Re: Follow-Up on Completing Regional Connector First-Last Mile Connections

Completing Regional Connector First-Last Mile Connections - detail addendum:

1.1 Grand Avenue Station

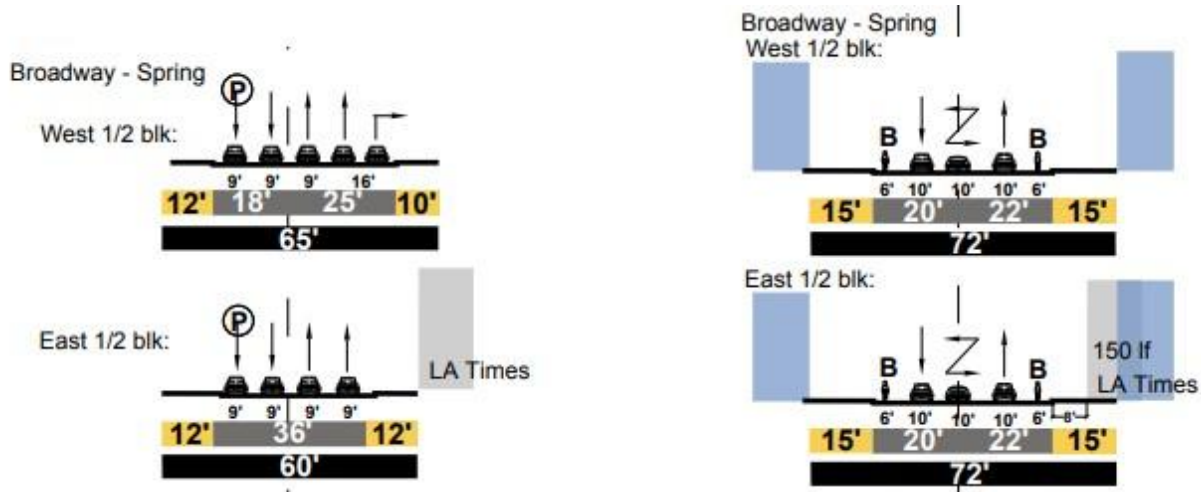
Your letter appears to state that, instead of following approved street standards (approved in 2009 after an extensive public input process, committee/commission/council hearings, etc.), Metro followed an unapproved and unreleased future City department plan for changes to Flower Street.

Metro installed a not-publicly-vetted design, different from what Metro approved in the Regional Connector EIR. Metro (and LADOT) apparently assumed that a future unapproved plan would not include bike lanes already approved in the Street Standards and the [Mobility Plan 2035](#).

Metro Grand Station area changes expanded car capacity with little to no regard for Metro riders arriving by foot or by bike. Modifying the current infrastructure there to match City/Metro plans would be prohibitively expensive. We urge Metro to implement a handful of easy low-cost bike/walk connections (and we will continue to advocate for any future Flower Street plans to prioritize the safety of Metro's riders - should the City's future plans ever come to a public approval process).

Remedy: Add bike/walk connections at Grand Station, including:

- Add missing crosswalk at Flower/Hope at the south leg of 2nd Place/Kosciuszko
- Add bike lanes:
 - Flower Street one-way (downhill) from 1st to 3rd
 - Hope Street one-way (uphill - west of station - protected) from 3rd to Kosciuszko
 - Hope Street one-way (uphill - east of station) from Kosciuszko to 2nd Street
 - 2nd/Kosciuszko (two-way - protected) from Flower to Hope
